**COUNTY OF SAN LUIS OBISPO
DEPARTMENT OF PLANNING AND BUILDING
STAFF REPORT**

Tentative Notice of Action

MEETING DATE September 1, 2006 LOCAL EFFECTIVE DATE September 15, 2006 APPROX FINAL EFFECTIVE October 6, 2006	CONTACT/PHONE Marsha Lee 788-2008	APPLICANT Harlan DeGroodt/Dave Brown	FILE NO. DRC2005-00150
SUBJECT Request by Harlan DeGroodt for a Minor Use Permit/Coastal Development permit to allow the construction of a new 3218 square foot, one-story single family dwelling including a 870 square foot three-car attached garage, and a 600 square foot guest house on Lot 7 of Tract 1804. The project will result in approximately 2100 cubic yards of fill and the disturbance of approximately 13,000 square feet of a 20,000 square foot building envelope, of a 1.37-acre parcel. The proposed project is within the Rural Lands land use category and is located at 6185 Brighton Lane, north of Weymouth Street in the community of Cambria. The site is in the North Coast planning area.			
RECOMMENDED ACTION Approve Minor Use Permit/Coastal Development Permit DRC2005-00150 based on the findings listed in Exhibit A and the conditions listed in Exhibit B.

Re: Cambria Pines Estates Tract 1804, Lot 7 Design Review

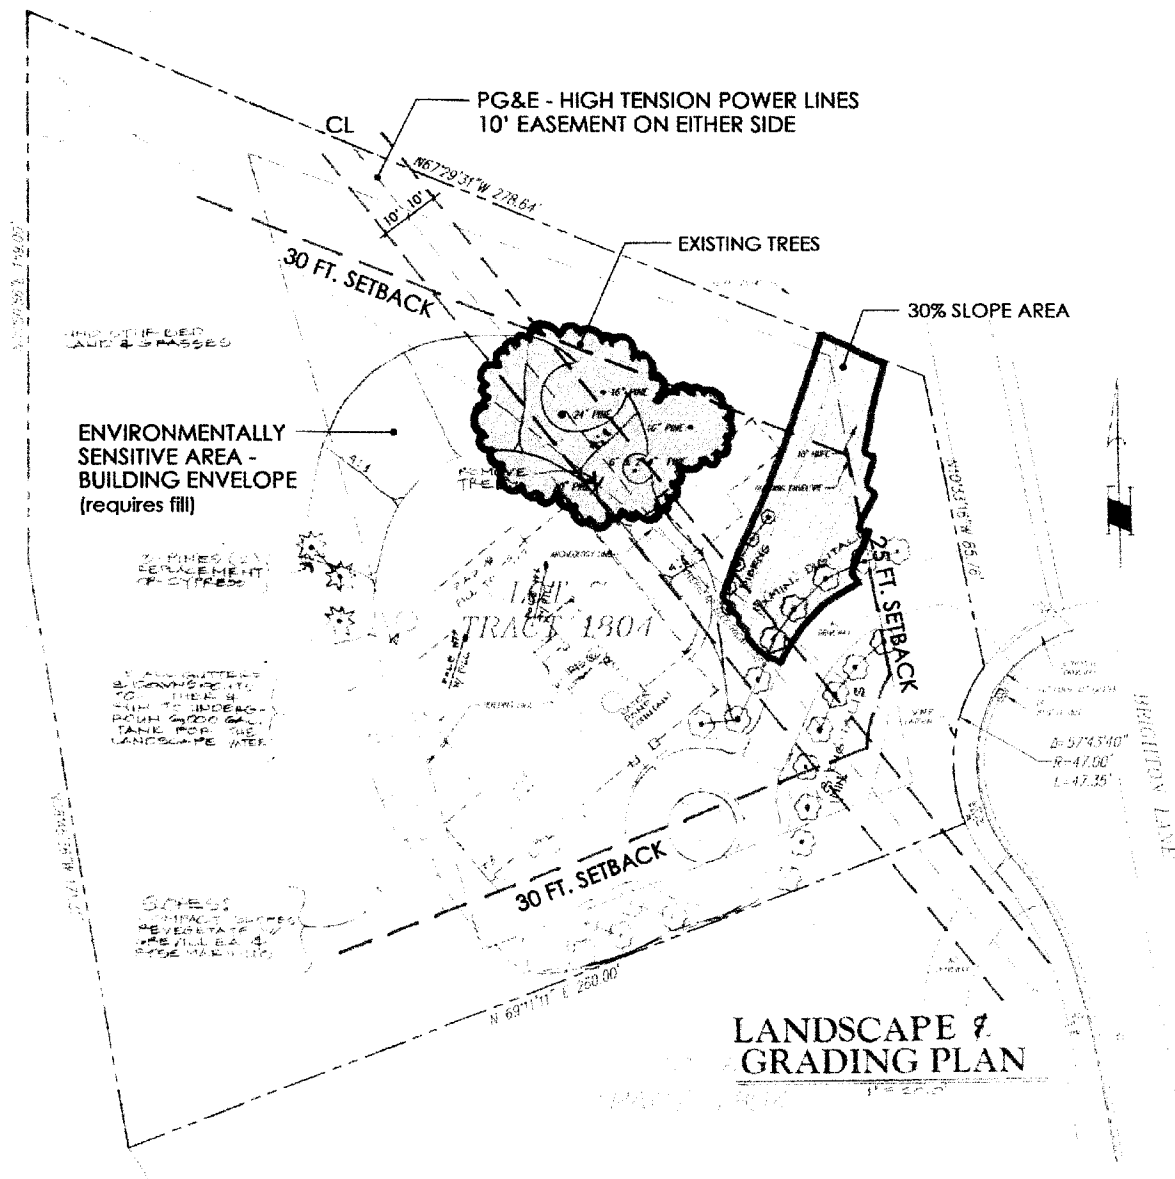
- 1) The architectural style and details are consistent with the intent of the Design Guidelines. Materials have a rural character fitting the style of the neighborhood and suggest muted earth tones. During construction plan review, please submit samples or photos of the stucco stone, shingle siding, and roofing material. Elevations shall also be provided at that time for the small roof deck and front courtyard. It is our understanding that the materials of wall around the front courtyard will be rock and should complement the stone on the residence. The materials used in the courtyard shall fit in character with the architectural design, and samples must also be provided during your construction plan review.

- 2) Views of the proposed home from Highway 1 are limited in both directions based on placement of the structure behind the existing highway berm located between Lot 7 and Highway 1. The photo simulation provided shows good use of the berm and existing vegetation for screening and softening the structural view. It is our understanding that the small roof deck is entirely recessed down within the roofline, and that nothing will protrude above the roofline such as windscreens or patio umbrellas.

- 3) Any exterior lighting proposed for the building will be hooded to reduce glare as recommended.
- 4) Grading is minimal and meets the requirements for fill on this site according to cultural and visual requirements (no silhouette). Some tree roots will be affected by grading for the driveway (see the section guidelines for Pine and Oak Tree Protection within the Design Guidelines manual). The Design Committee recognizes that you have worked with the archaeologist on the amount of fill required over the culturally sensitive area, and that you have minimized the fill to reduce the visual disturbance to the site by the use of a sewer pump. The Design Committee understands you will provide alternatives for the placement of the garage and driveway in order to reduce grading outside of the building envelope. The

house is well sited based on the extent of constraints located on this site and the committee recognizes that minor grading outside the envelope is necessary to provide a transition to natural grade.

- 5) Due to the site restrictions, some Cambria Pines trees will be affected. Tree removal requires a replacement ratio of 4:1. Planting local native Cambria Pine trees on the fill slope to provide 'softening' of views from Highway 1 is desirable. Careful placement will enhance views from the house as well as toward the house. The retaining walls around the existing trees should fit into the overall architectural character, and photographs and/or elevations shall be provided depicting the retaining walls around the existing trees during your construction plan review phase.

- 6) Landscape materials consist of drought-tolerant species consistent with the recommendations of the Design Guidelines. Graded slopes should be planted or seeded with local native grasses or shrubs as a transition to the open space and to control erosion. The Design Committee suggests a unified plant palette with Lots 6 and 8 along the southwest side of the site in order to create a unified and consistent view from Highway 1. This coordination can occur during the construction document preparations.

- 7) Fencing is not allowed along property lines. If any fencing other than the courtyard is proposed, please submit plans consistent with the Design Guidelines during your construction plan review phase.

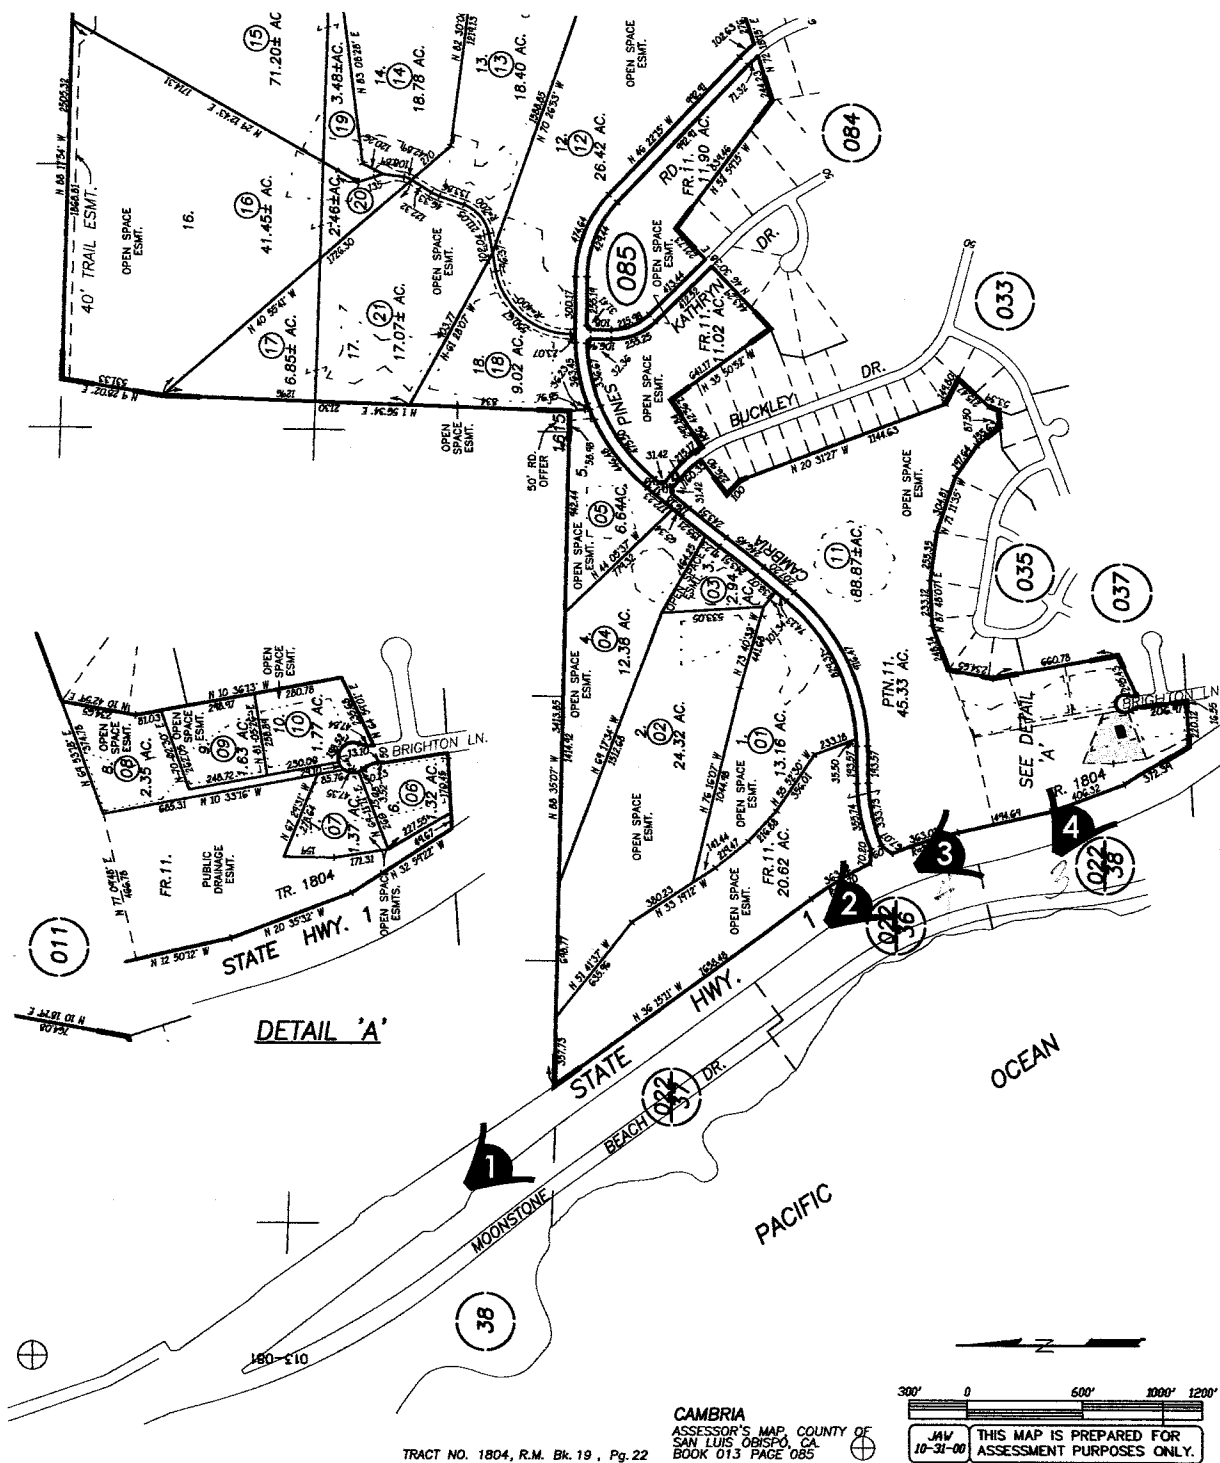
The project will not generate significant visual impacts if the following items are conditioned into the final conditions of approval:

- Addition of a 3-4' low landscape, shrub cover along the northwest patio to eliminate the view of the top of passing cars from the proposed residence and reduce the view of the residence from the Highway.
- Addition of one vertical tree to be planted northwest of Master Bath 2 to divide the building mass, provide a visual break in the roof line and, incidentally, to insure privacy in bathroom.
- The architectural roof forms are retained as shown.
- The roof height is restricted to 18 feet.
- The muted and mixed nature of building colors are retained as identified in Figure 2: Architectural Elevation.
- The proposed gas fireplace will installed/constructed as designed, and will not require a visible chimney which silhouettes the skyline.
